**LEVY NUCLEAR PLANT, UNITS 1 AND 2
DOCKET NOS. 52-029 AND 52-030
VOLUNTARY SUBMITTAL FOR COL APPLICATION PART 11 – ENCLOSURES –
ALIGNMENT OF LEVY QAPD WITH DUKE ENERGY CORPORATE QAPD AND UPDATE TO
LEVY REQUEST FOR ADDITIONAL INFORMATION LETTER NO. 010 RELATED TO QAPD**

**Duke Energy Quality Assurance Topical Report for
10 CFR Part 52 Licenses
NGGM-PM-0033**

Revision 6

Figure II.1-1

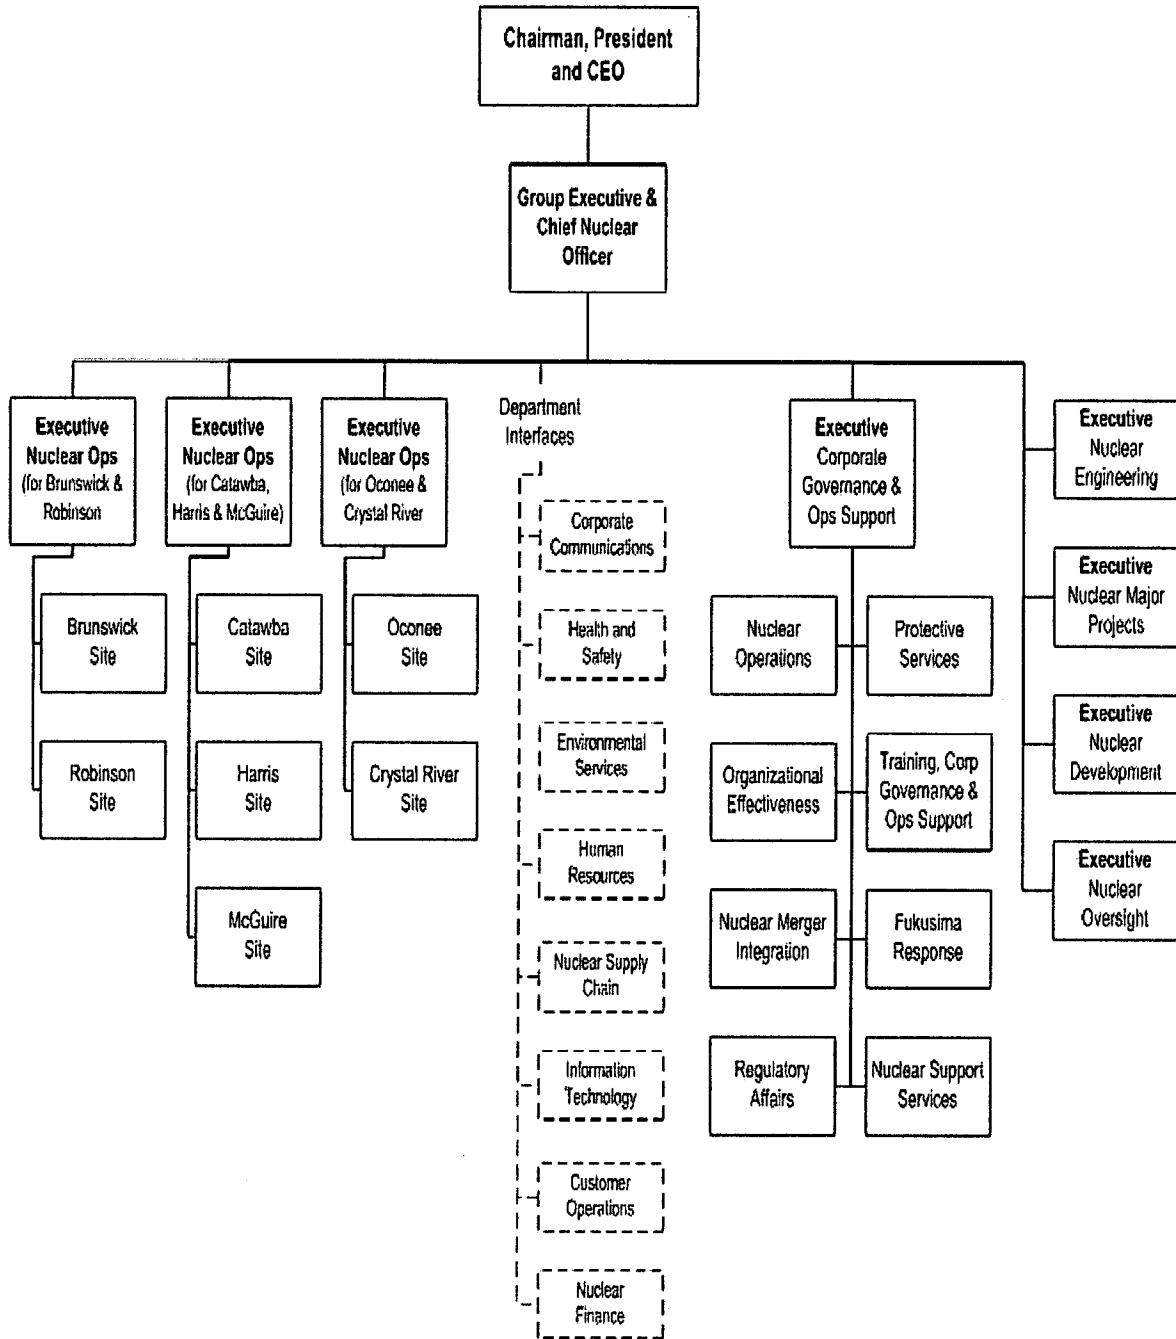
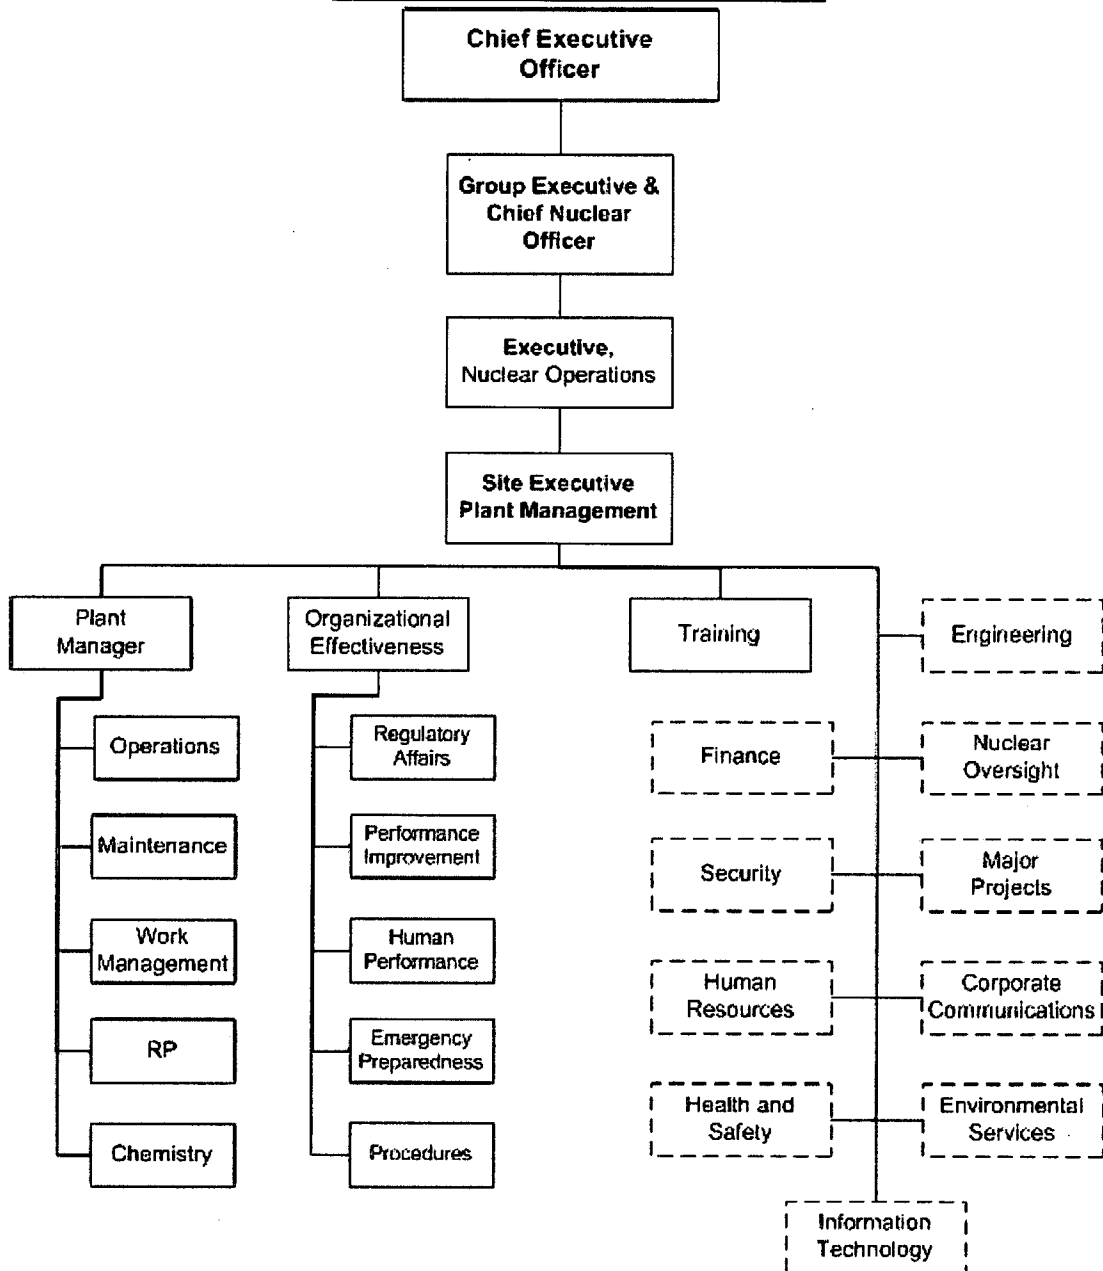
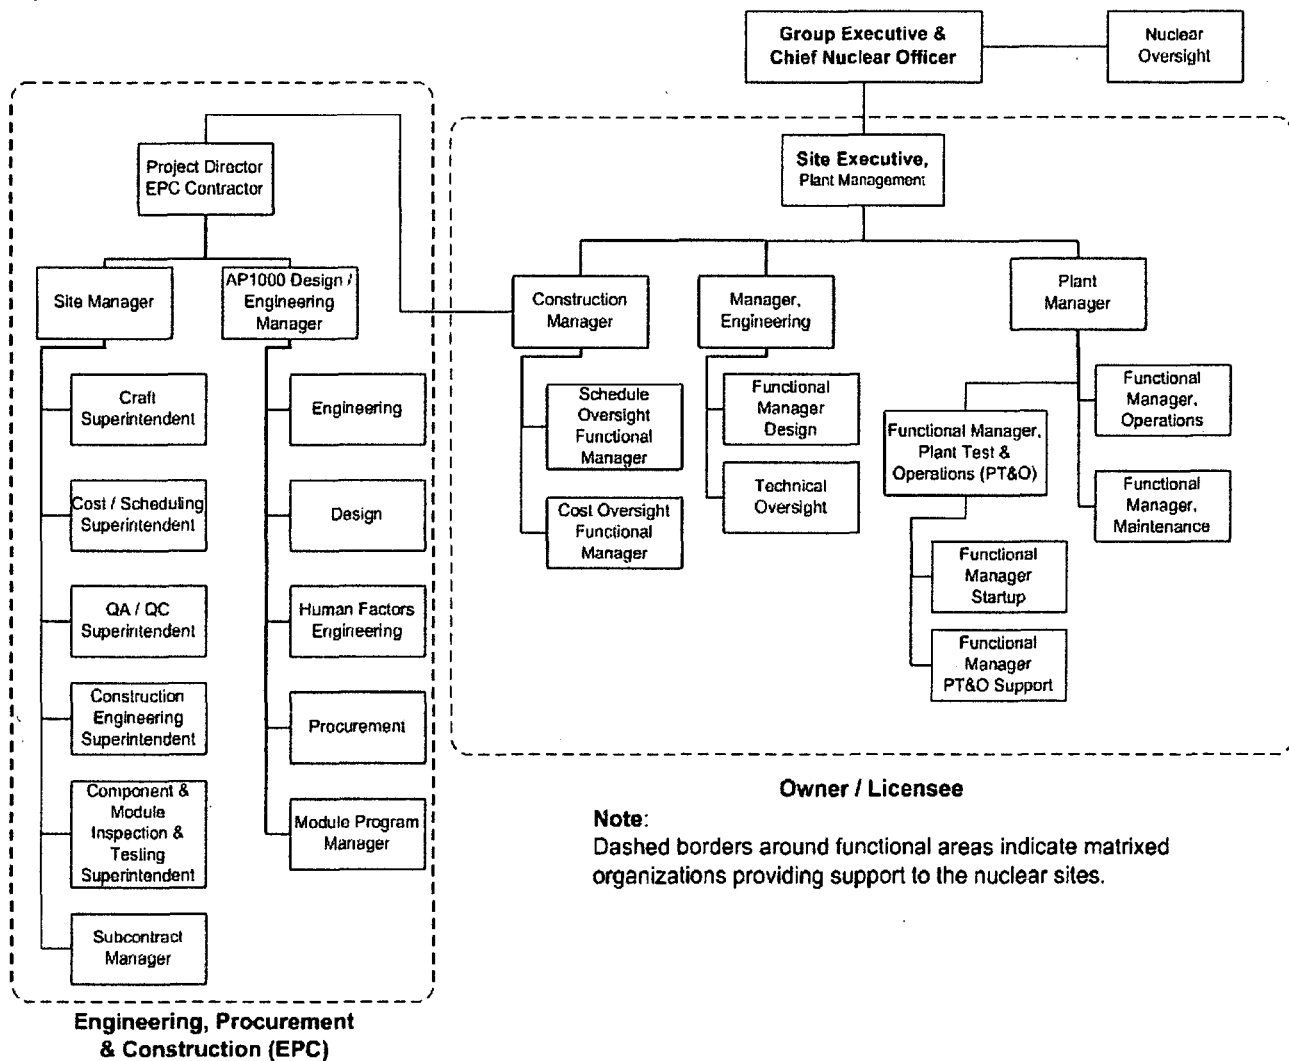
- Revised Figures II.1-1, II.1-2, and II.1-3 to reflect revised corporate, operational phase and construction phase organizations and alignments.
- Part II Sections 2 through 18 made changes to be consistent with standard approved language in NEI 06-14A rev 7 dated August 2010.
